11-08 LATEST REVISION DATE <i>Thomas E. McQuinn</i> APPROVED BY BRIDGE ENGINEER	 Iowa Department of Transportation Highway Division STANDARD DESIGN - 40' ROADWAY, 3 SPAN BRIDGES CONTINUOUS CONCRETE SLAB BRIDGES NOVEMBER, 2006
	MONOLITHIC PIER CAP DETAILS ALL BRIDGES
J40-26-06

HALF SECTION NEAR PIER
 SHOWING STIRRUP SPACING AND NUMBER OF PILING
 NOTE: BOTTOM OF CAP ELEVATIONS WILL BE REQUIRED AT THE
 CENTER OF ROADWAY AND AT EACH EXTERIOR PILE.

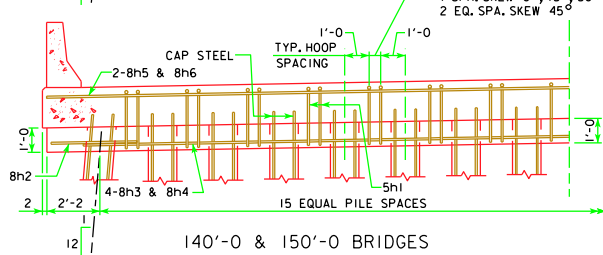
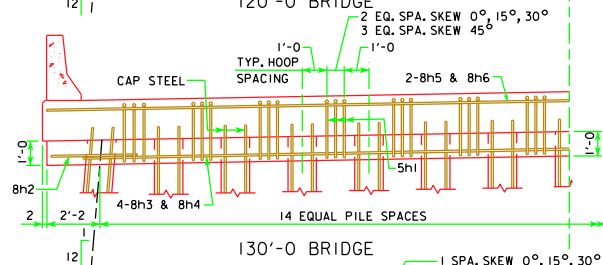
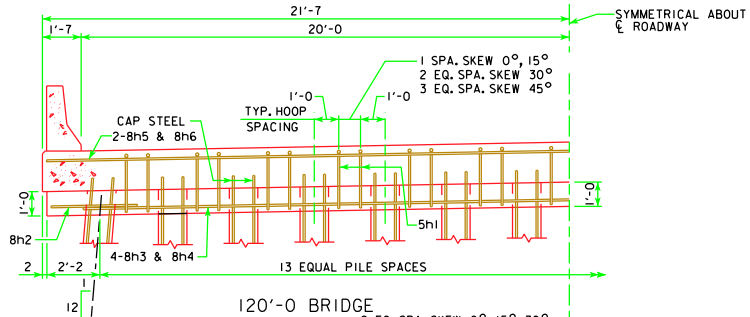
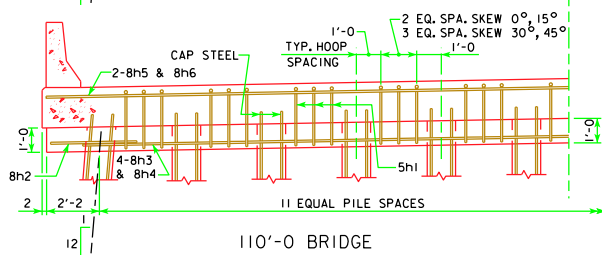
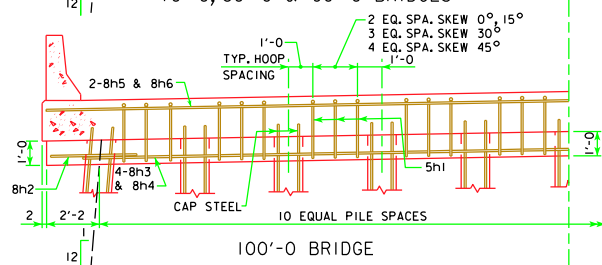
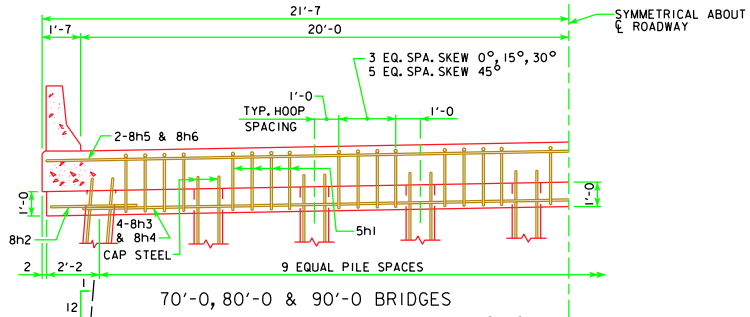
REVISED 11-08 - REVISED PILES REQUIRED FOR 120'-0 AND 130'-0 BRIDGES.
